# ADDENDUM NO. 2

## 2013 - Town of Lewis - Carlott Road Bridge Construction

Essex County, NY

DRAWING TITLE  
CARLOTT ROAD BRIDGE  
OVER SPRUCE MILL BROOK  
BRIDGE REPLACEMENT  
DECK FRAMING PLAN  
AND SECTIONS

DRAWING NO. **S-1** SHT. 1 OF 3  
REV. 2

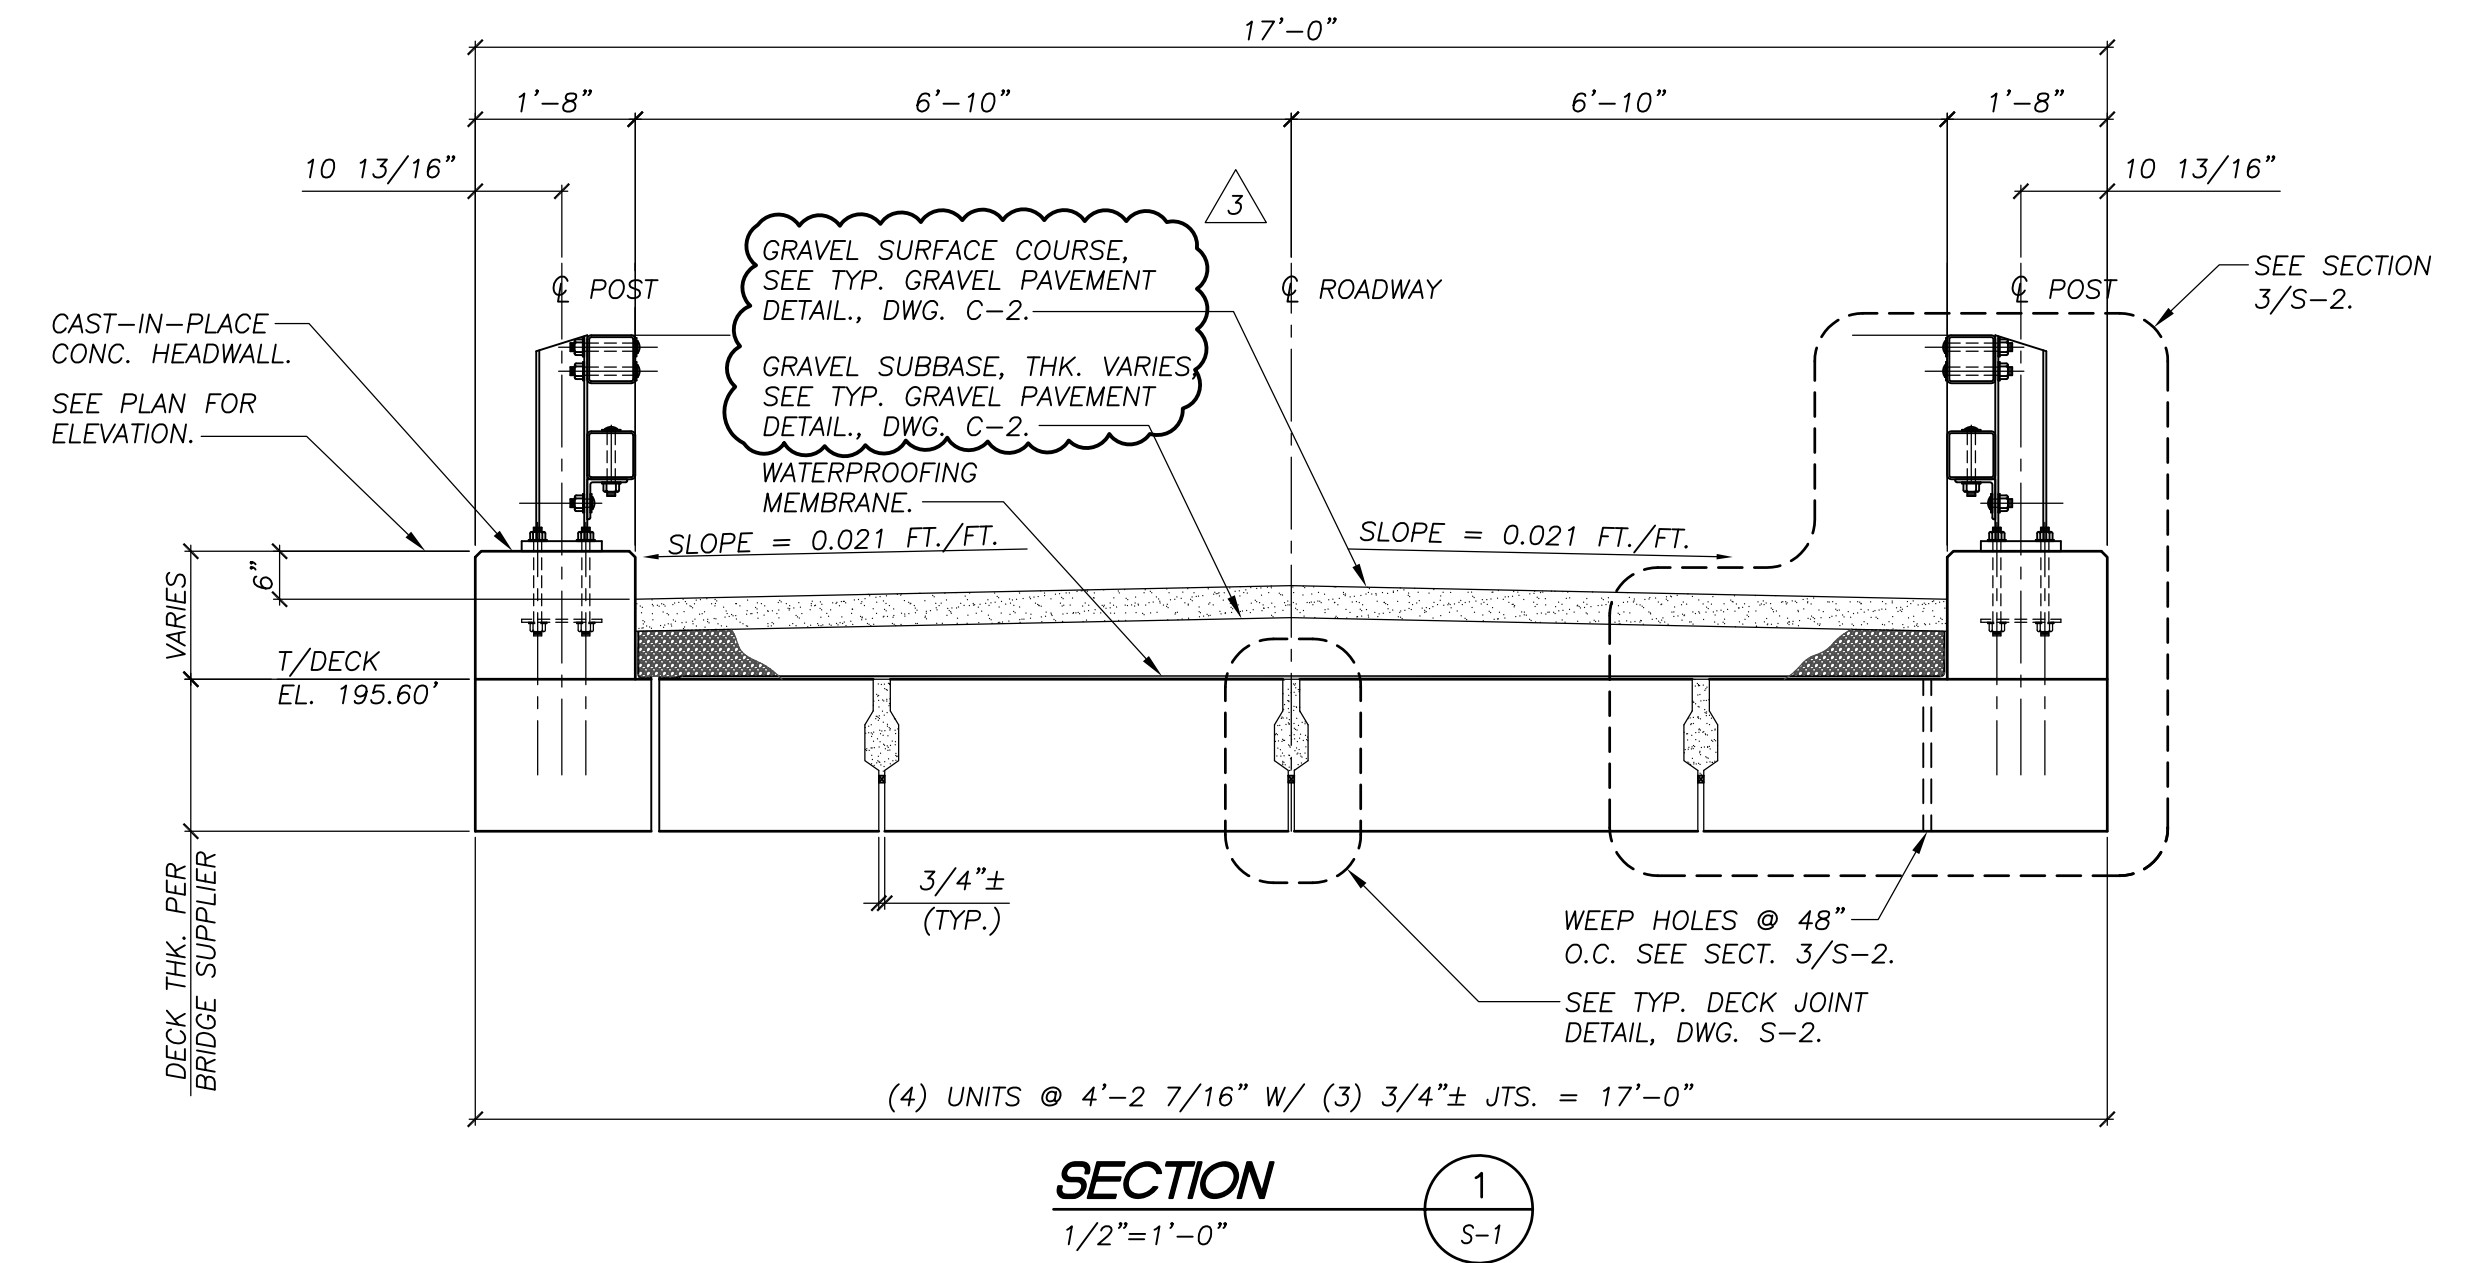
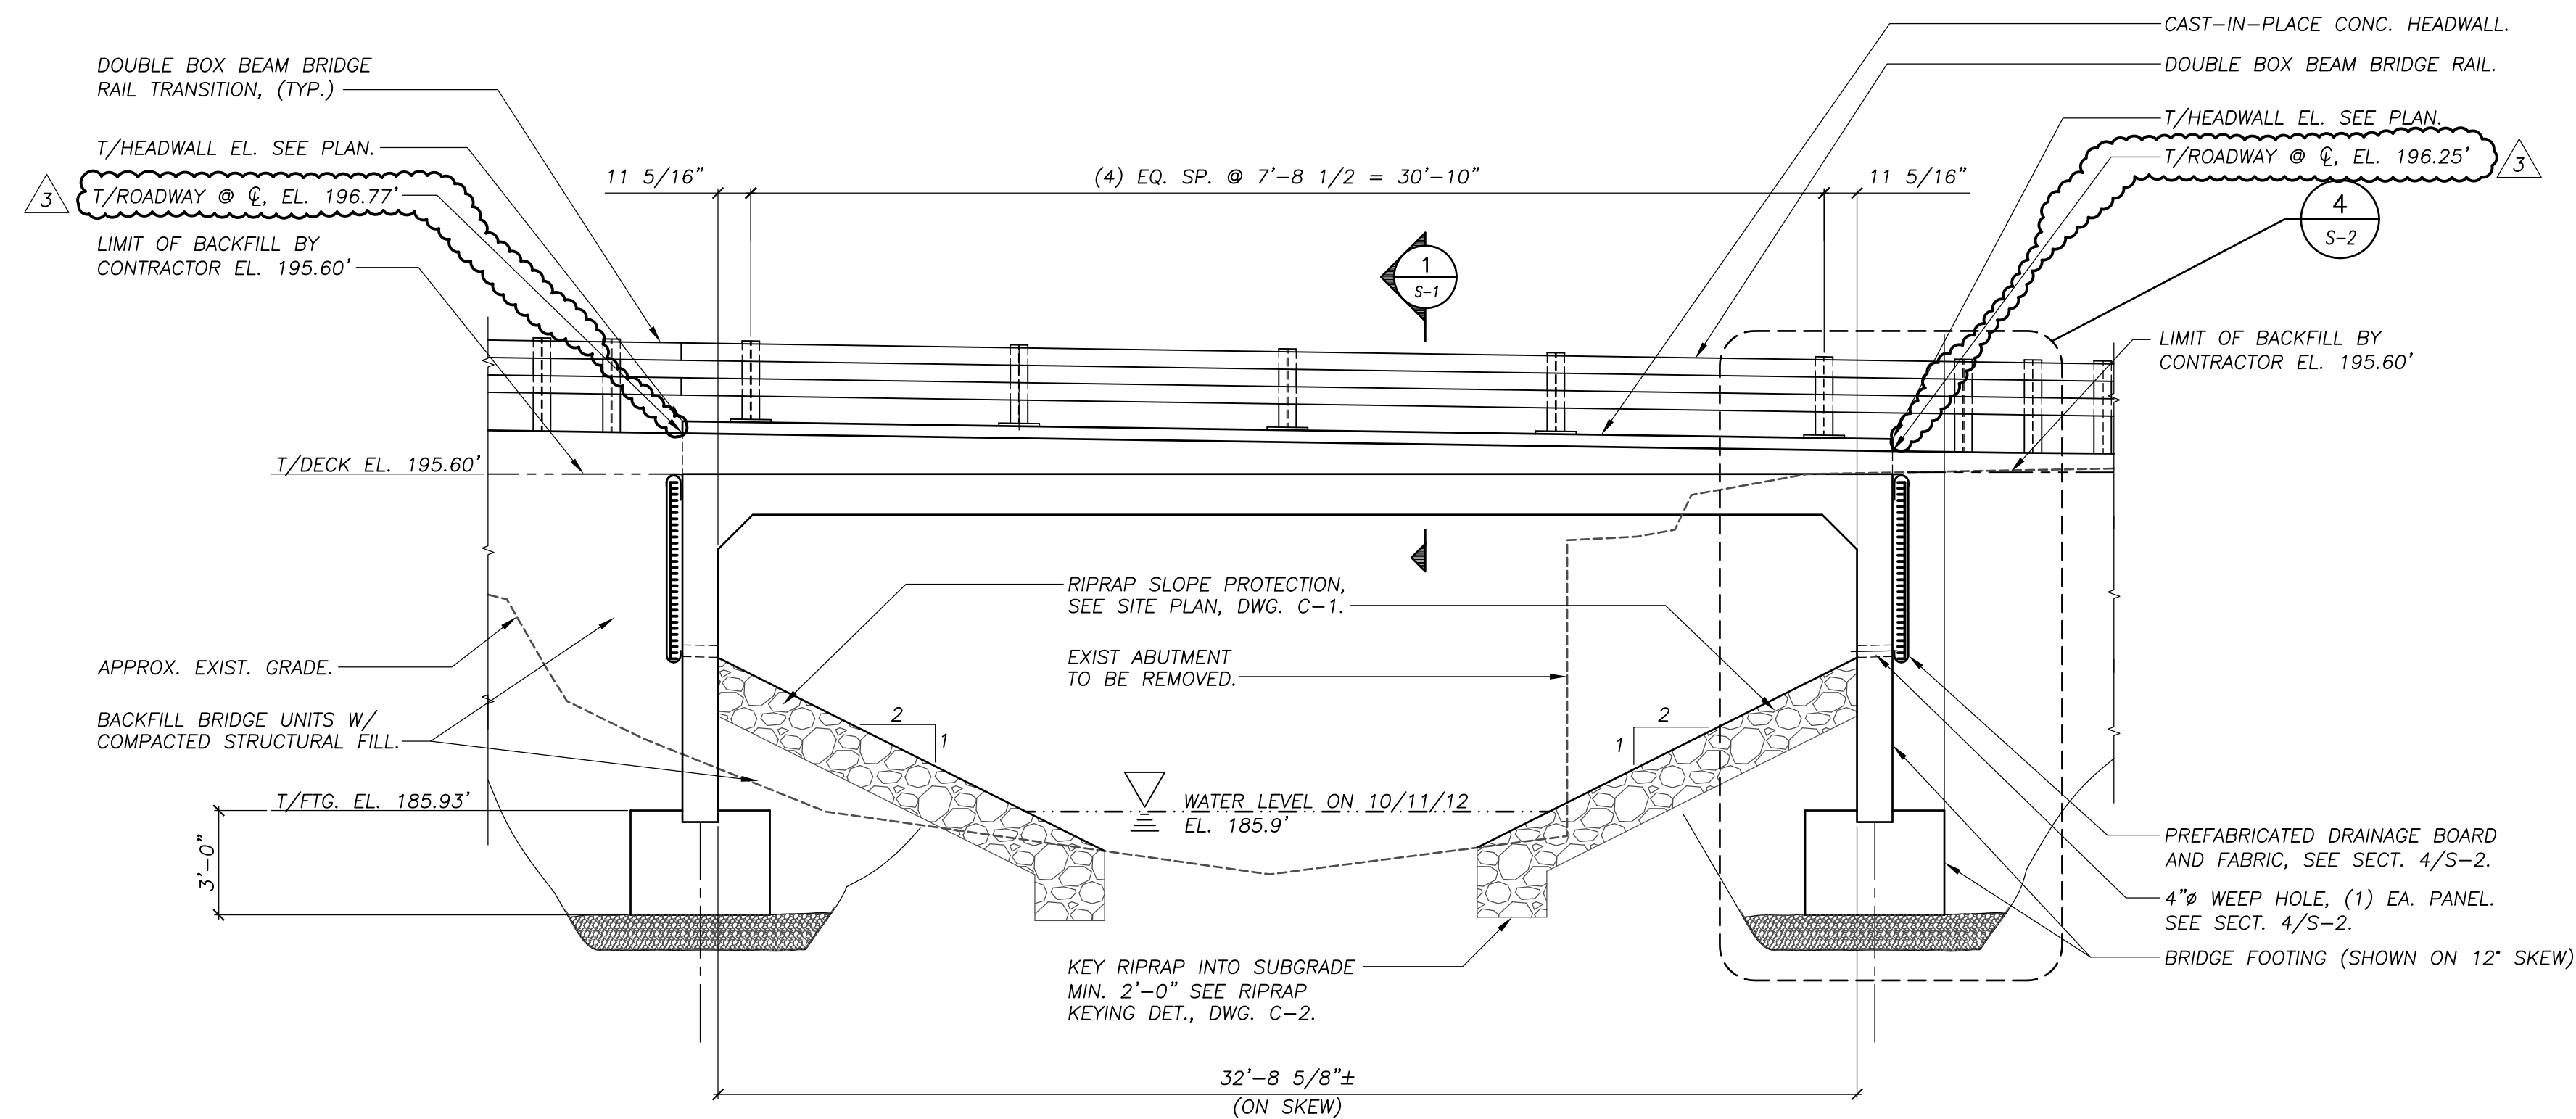
1. **General:** The date for receipt of bids has been changed to April 24, 2013 at 12:00 PM. Modify the information indicated in *Notice to Bidders*, first paragraph, 2<sup>nd</sup> and 3<sup>rd</sup> lines accordingly.
2. **Regarding *Project Schedule*:** Change the Pre-bid Meeting Onsite date indicated from "April 9, 2013 at 9:00 AM" to "April 16, 2013 at 9:00 AM". Change the Bid Opening Date indicated from "April 17, 2013 at 12:00 PM" to "April 24, 2013 at 12:00 PM".
3. **Regarding *Drawing S-1 Deck Framing Plan and Sections*:** DELETE the copy of this drawing included in Addendum No. 1 and SUBSTITUTE THEREFORE the attached Drawing S-1, Revision 3 bearing the Revision Date 4/3/13.
